ISSUE: Permit to Demolish/Capsulate (partial) and Certificate of Appropriateness for (alterations, addition)

LOCATION: Old and Historic Alexandria District
1309 Prince Street

STAFF RECOMMENDATION

UPDATE

Figure 1: Proposed demolition at west elevation

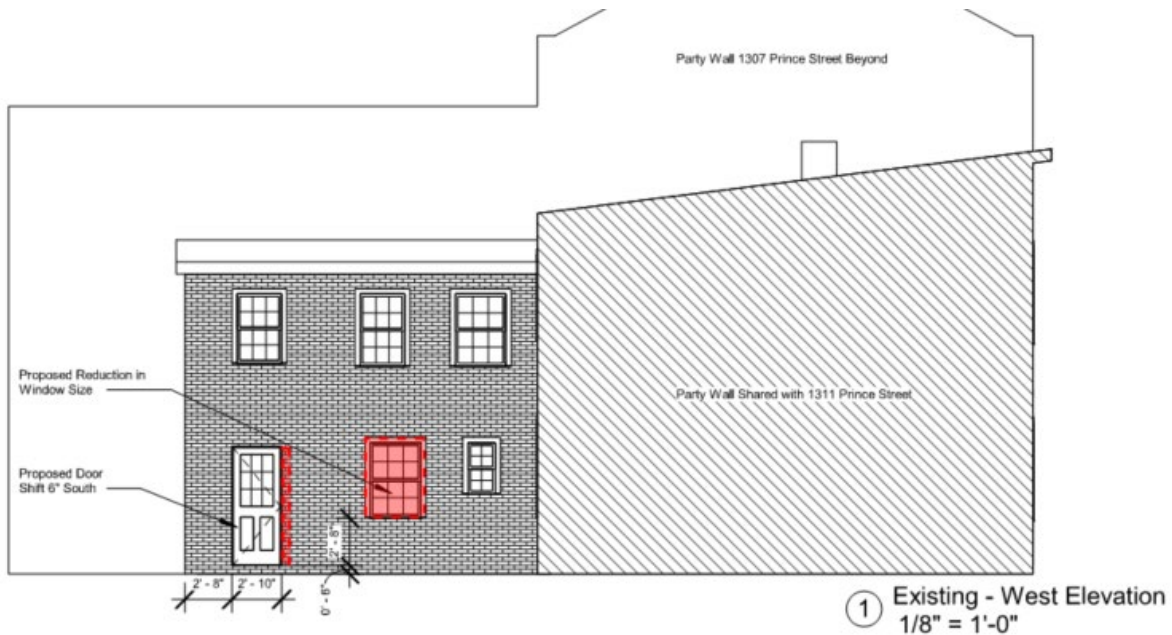
In the opinion of staff, none of the criteria for demolition of the portions of the north and west sides of the existing building or the existing chimney are met and the Permit to Demolish/Capsulate should be granted. The proposed opening in the north elevation is consistent with masonry openings found throughout the historic district. In addition, only the top portion of the opening will be visible from the street above the wood fence at the rear of the site. The modification to the door opening is minimal in size and visible only at an oblique angle above neighboring fences. Upon review of the existing window to be removed, it has been determined that this is a modern

window and not original to the structure. Its demolition would not represent the loss of historic materials. The *Design Guidelines* say that “Existing chimneys should be maintained in situ and not removed without a compelling reason and substantial justification.” In this case, the chimney is not visible from the front of the house and does not contribute to the overall composition of the north elevation. See Figure 1 and Figure 2 below for the extent of the proposed demolition, in red.

1. The windows comply with the *Alexandria New and Replacement Window Performance Specifications in the Historic Districts*
2. Bricks removed from the building be saved and used to patch around the revised door location and below the sill of the modified window.

Figure 2: Proposed modifications to west elevation

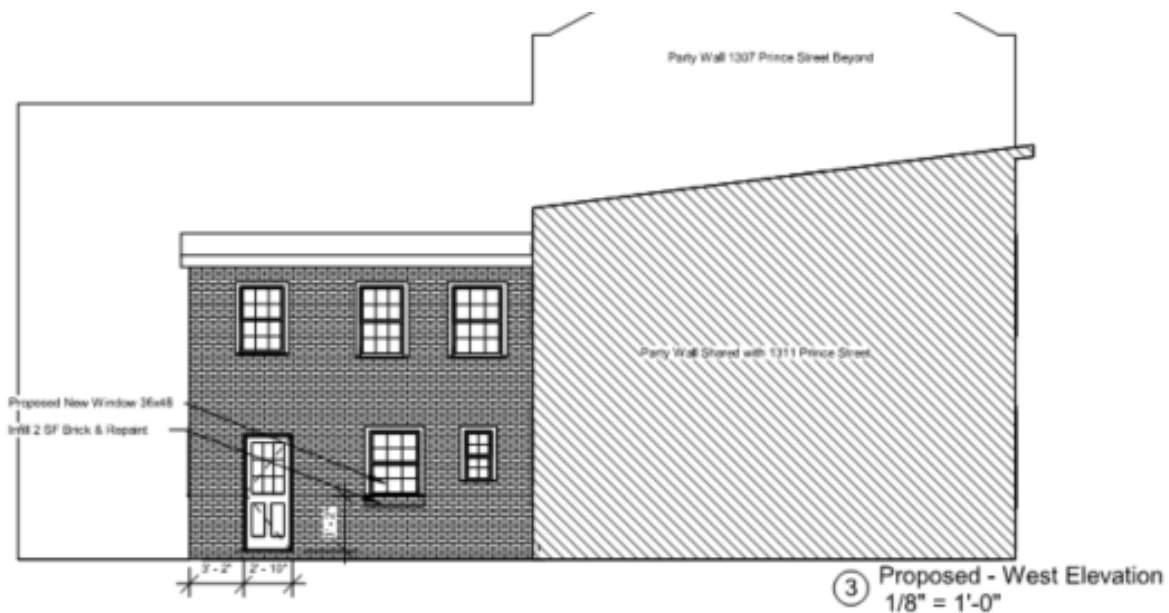
The applicant proposes to modify the north and west elevations of the existing rear ell through the introduction of a ground floor window on the north wall, the relocation of the existing door on the west wall and raising the sill on the ground floor window on the west elevation (Figure 3 & 4). The changes to the west elevation are being made to accommodate the kitchen on the ground floor of the ell. The new window on the north elevation is being introduced to bring light into this kitchen.

The *Design Guidelines* state that “Exterior doors and storm doors constitute prominent visual details of the main façade of a building...Care should be taken that the character defining features of these doorways are maintained... Doors and their surrounds are as much a character defining feature of architectural styles as windows.” Furthermore, “Windows are a principal character defining feature of a building and serve both functional and aesthetic purposes...Changes to windows can have a dramatic impact on the historic appearance of a structure...New and replacement windows should be appropriate to the historic period of the architectural style of the building.” Staff does not object to the introduction of a new window on the north elevation as it adds character to this otherwise undistinguished elevation and the majority of the window will not be visible from the street. Staff also does not object to the proposed modifications to the door and window on the west elevation of the ell. As demonstrated above, these elements are only minimally visible from the public right of way and then only at an oblique angle. Because of this angle, any alignment between the door and the window above will not be evident. The proposed modification to the window on the west elevation of the ell will be below the line of the fence and will therefore not be visible from the public right of way and the new window will not be perceptibly different from the one currently in place.

Staff supports the proposed Permit to Demolish/Capsulate (partial) and Certificate of Appropriateness for the proposed work at 1309 Prince Street with the following conditions:
